STATE OF NORTH CAROLINA  
DEPARTMENT OF TRANSPORTATION

SUBJECT: **Revision Request for Section 404 Regional General Permit No. 31 and Section 401 General Water Quality Certification No. 3886** for the proposed Interstate 85 (I-85) Widening and Interchange Improvements from north of NC 73 (Davidson Highway / Exit 55) to north of SR 2180 (Lane Street/Exit 63), Cabarrus & Rowan Counties, Divisions 9 and 10. Federal Aid Project No. FANHIMF-085-2(61)55, TIP Project No. I-3802A.

Revisions have been made at Sites 7, 7A, 14, and 22. Below are descriptions of the revisions at each of these sites. In addition to this cover letter, please find enclosed revised Wetland and Stream Permit Drawing Sheet Nos. 15 – 20, 41 – 44, 71 – 74, and 126 – 128 of 128; and the revised Mitigation Acceptance Letter from the N.C. Division of Mitigation Services (DMS).

1" = 100'  
 GRAPHIC SCALE  
**PERMIT DRAWING SHEET 15 OF 128**

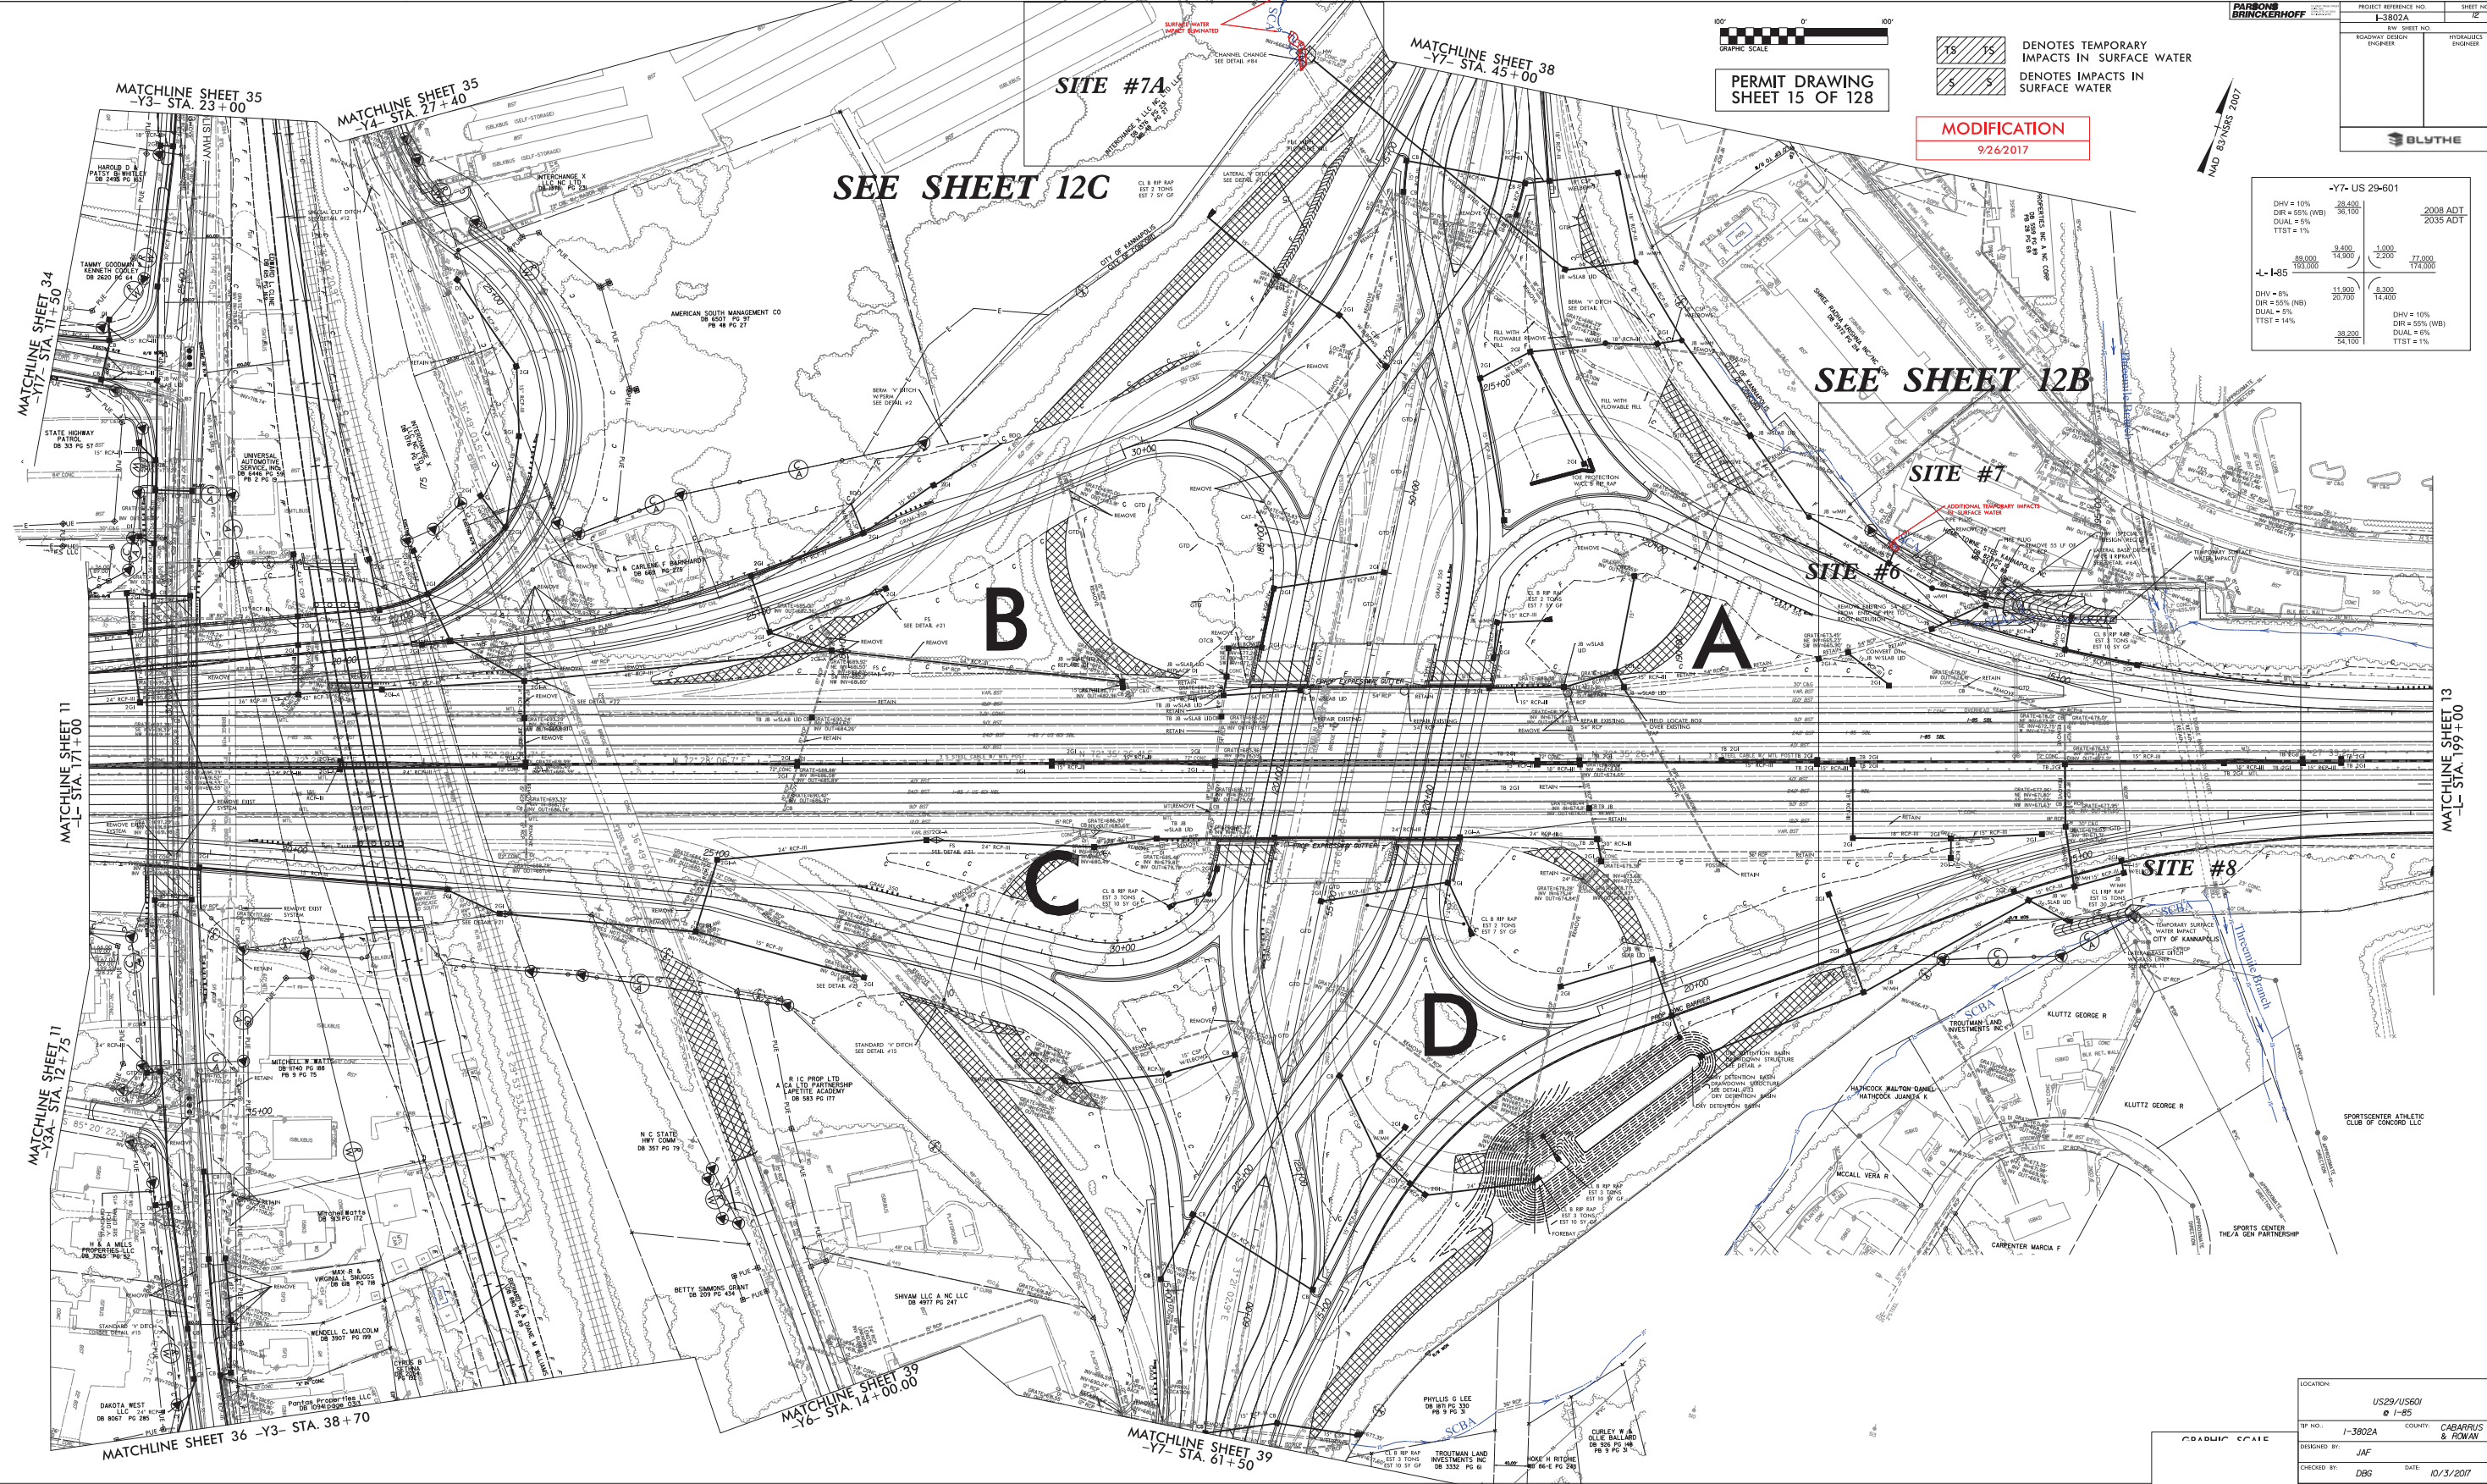
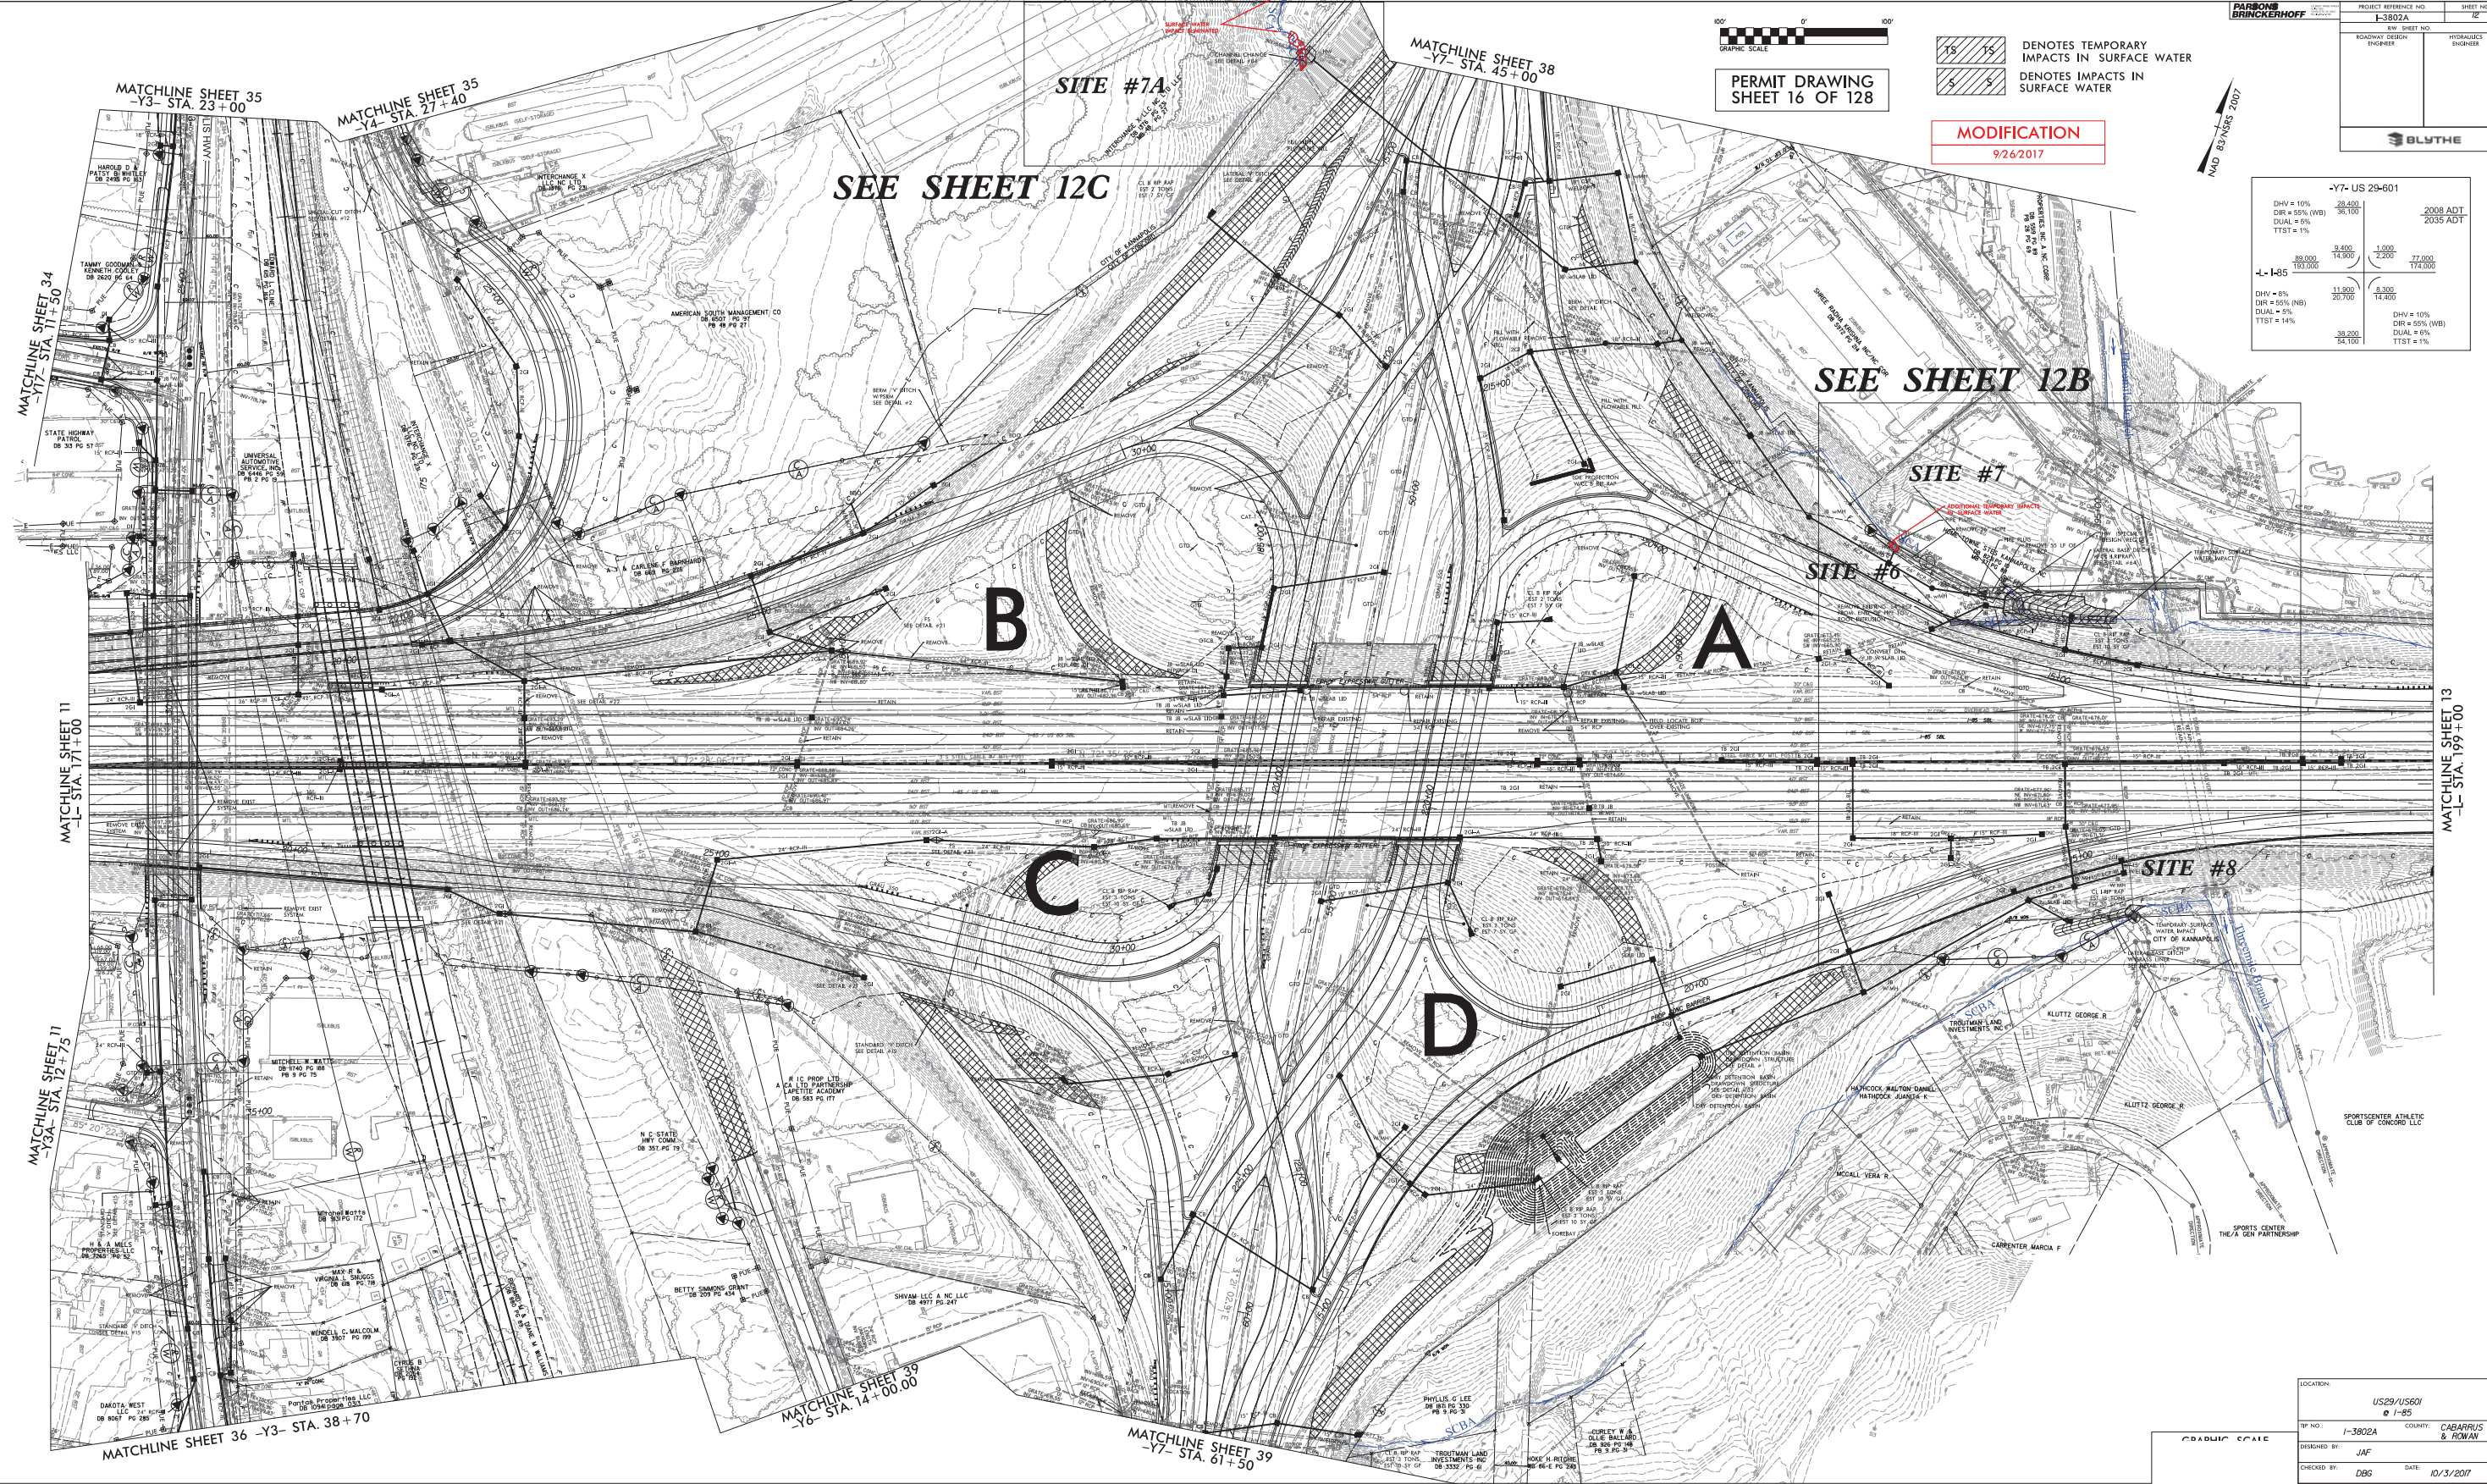
### *Wetland and Stream Permit Site 7 (Stream SCA)*

The pipe headwall at this location had to be moved. Therefore, an additional 10 linear feet of temporary surface impact has been added to Site 7 to accommodate the new headwall location. Impacts increased from 10 linear feet of temporary impacts to 20 linear feet.
